Comcast

Plant Maintenance Request **V5** Job number **NW421**
 Node DB141 City Maple Grove Date 10/5/2016
 Address 9785 67th Ave N Cross Street Magda Dr
 Maint tech Name: Nathan Krick Tech # 1570 Phone: (612) 875-6664

Cable is damaged under driveway causing bad levels at taps.

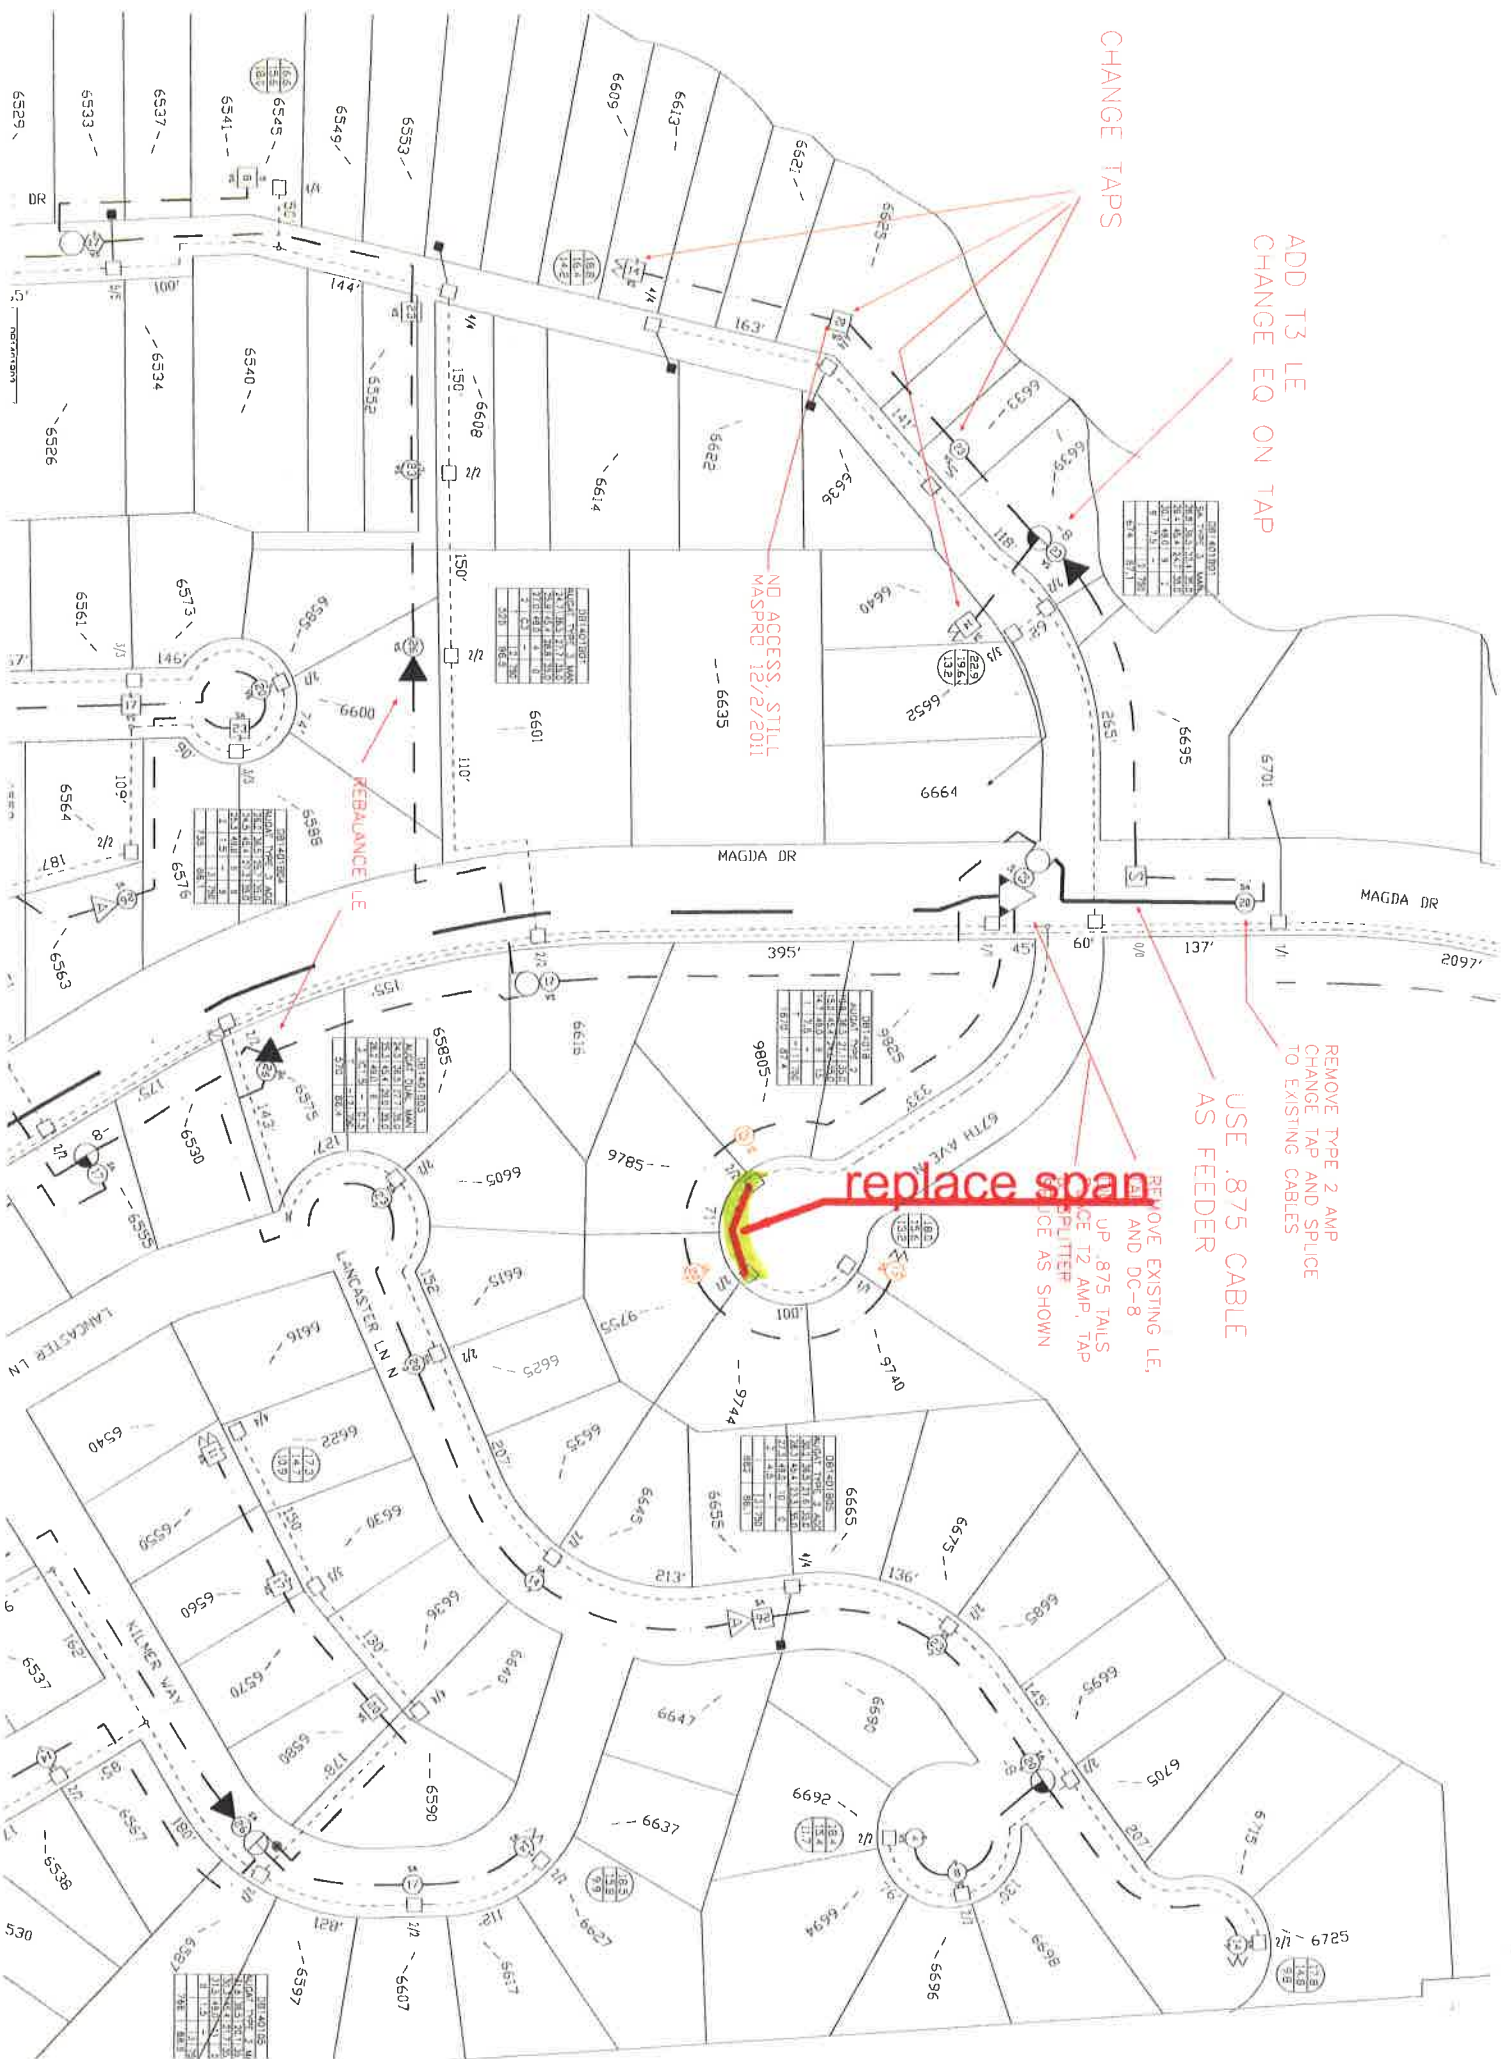
CHANGE TAPS

ADD T3 LE
CHANGE EQ ON TAP

REBALANCE LE

replace span

REMOVE TYPE 2 AMP
CHANGE TAP AND SPLICE
TO EXISTING CABLES

USE .875 CABLE
AS FEEDER

REMOVE EXISTING LE,
AND DC-8
UP .875 TALS
REPLACE T2 AMP TAP
PLUTTER
POLICE AS SHOWN
